STATE OF MAINE
DEPARTMENT OF TRANSPORTATION
16 STATE HOUSE STATION
AUGUSTA, MAINE 04333-0016

February 19, 2021
Subject: International Bridge
Rehabilitation
State WIN: 021736.00.00
Location: **Madawaska &
Edmundston, Canada
Amendment No. 7**

Please make the following changes to the Bid Documents:

SHEET NUMBER
149
OF 160

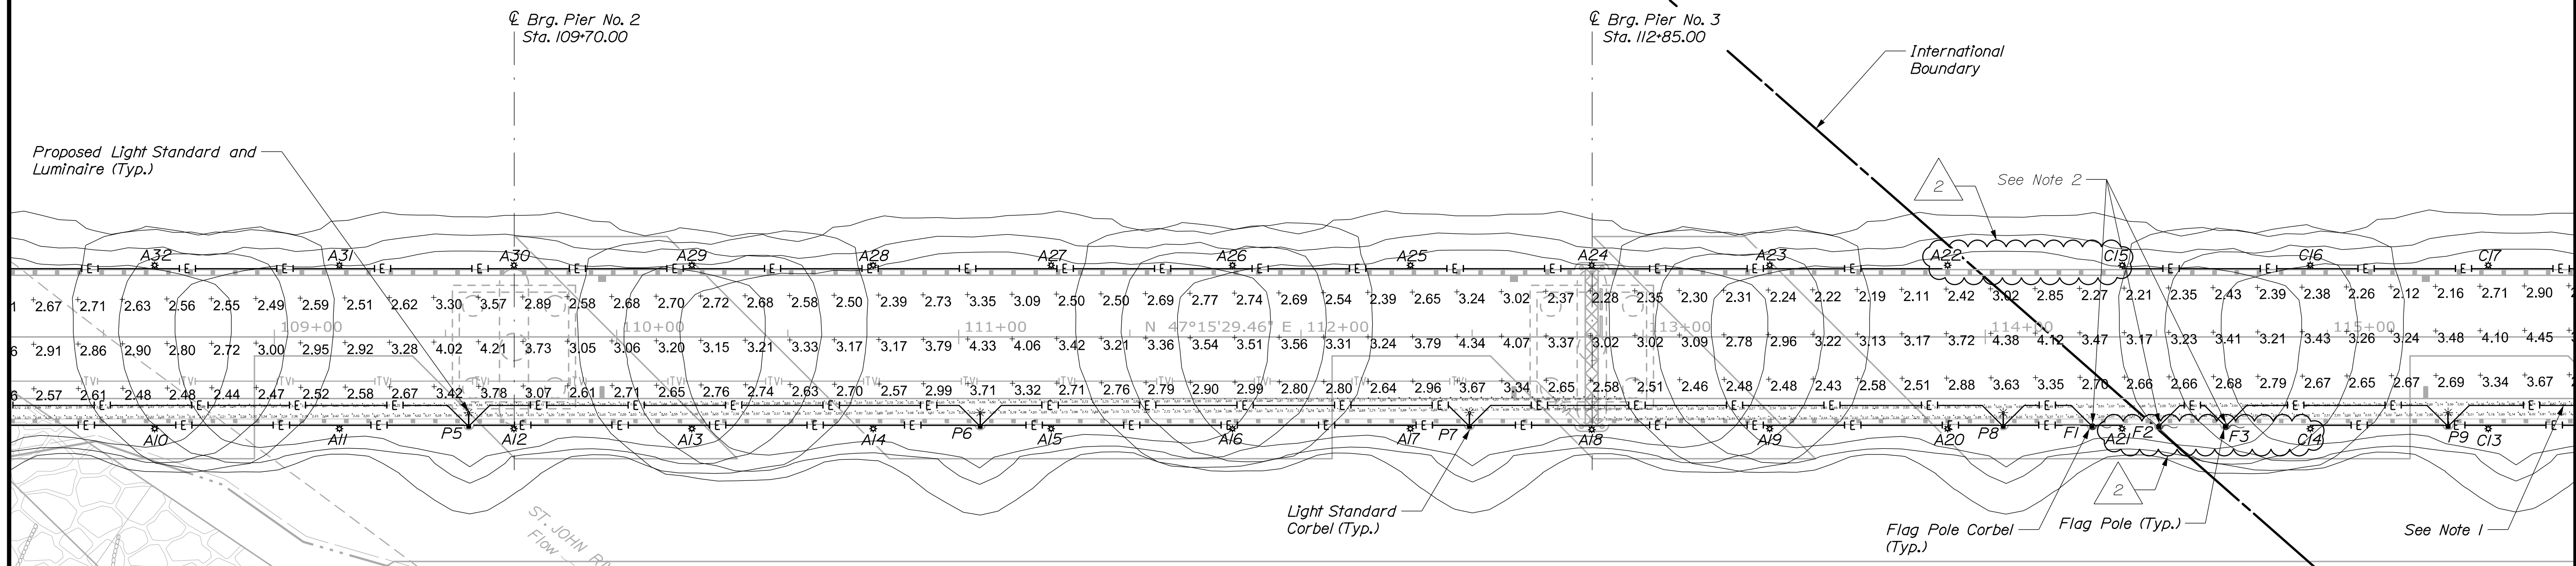
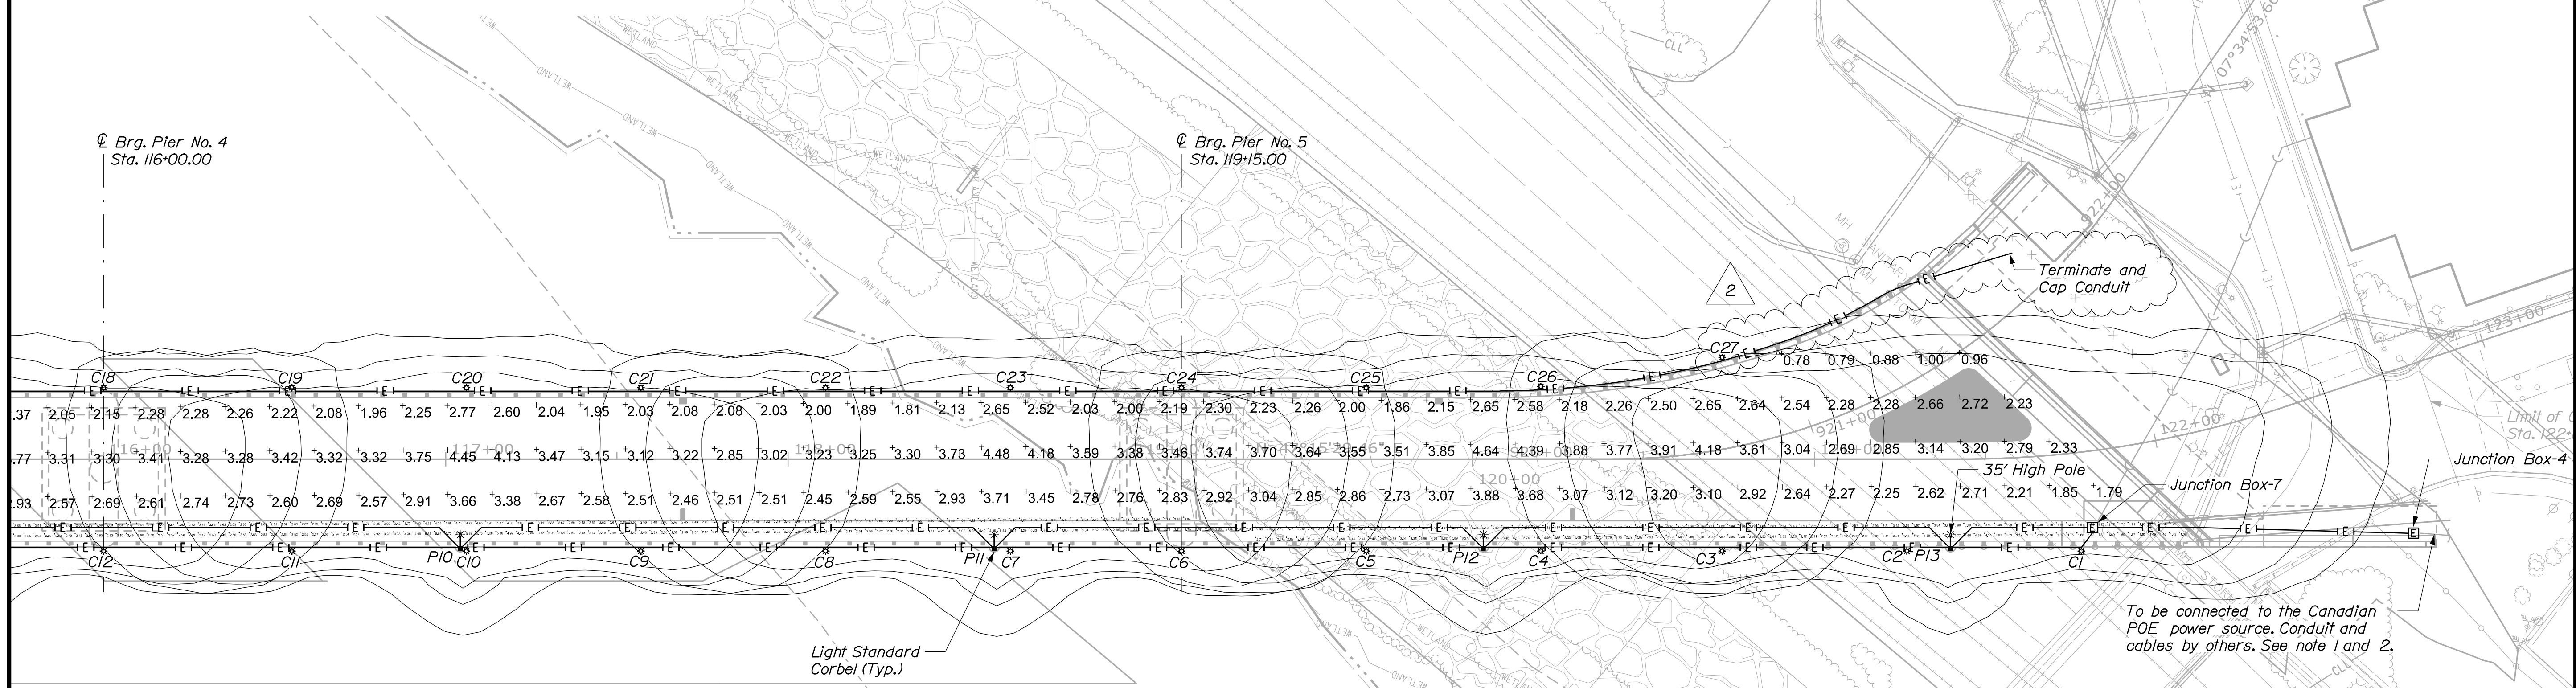
REMOVE from Amendment No. 3, SHEET NUMBER 149 OF 160, BRIDGE LIGHTING PLAN-2, dated 1/28/2021, and **REPLACE** with the attached, revised SHEET NUMBER 149 OF 160, BRIDGE LIGHTING PLAN-2, dated 2/18/2021.

Question: There is no path indicated for the power to get to the Aesthetic lights from the Canada side from Junction box 4 or 7 to the north side of the new bridge, can you please provide this information.

Response: See attached, revised Plan sheets 149 and 150 of 160, Bridge Lighting Plan-2, and Bridge Lighting Plan-3, respectively. The approach conduit routing for aesthetic lighting within the Canadian Port of Entry, beyond that shown on the attached, revised Plans, is beyond the limits of this Contract. Final routing will be determined in the field and will require coordination with the Design Team who is preparing the plans for the modifications to the Canadian Port of Entry.

BRIDGE LIGHTING PLAN - 3

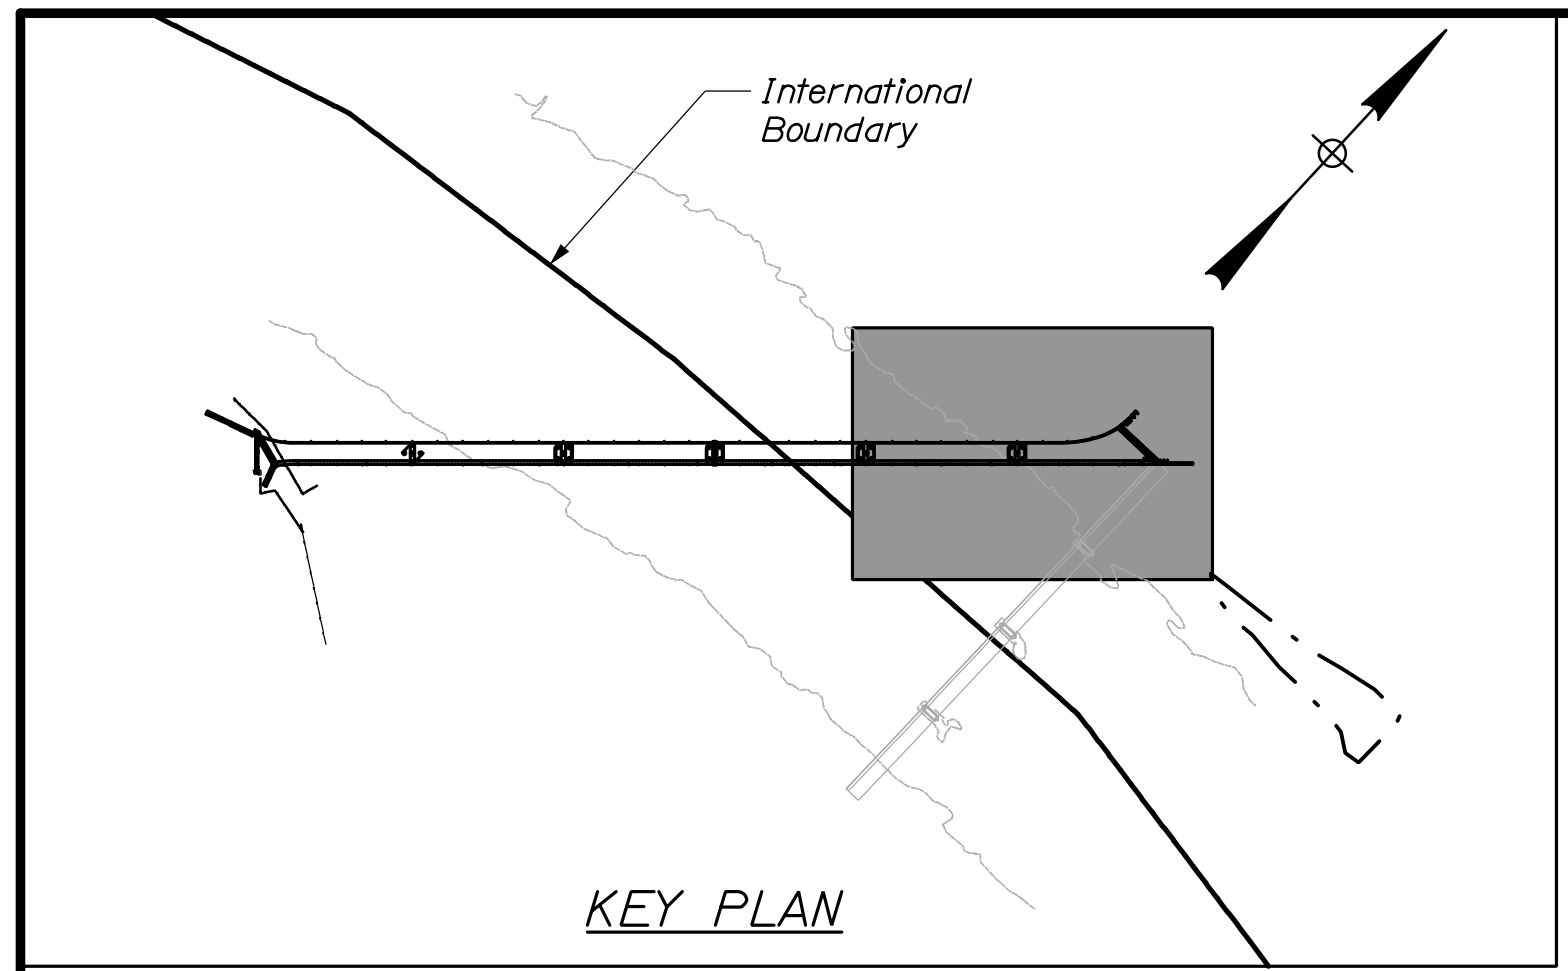
REMOVE from Amendment No. 3, SHEET NUMBER 150 OF 160, BRIDGE LIGHTING PLAN-3, dated 1/28/2021, and **REPLACE** with the attached, revised SHEET NUMBER 150 OF 160, BRIDGE LIGHTING PLAN-3, dated 2/18/2021.

2. Aesthetic lighting fixtures C1 to C27 shall be connected to a Canadian POE power source (by Others). One (1) 240V circuit shall be provided to power the Aesthetic Lighting fixtures. Conduit and wiring shall be 2 inch conduit with two (2)*6 AWG type XHHW and one (1)*6 ground. Installation and connection of cables between Junction Box-4 and Canadian POE power source shall be by Others.
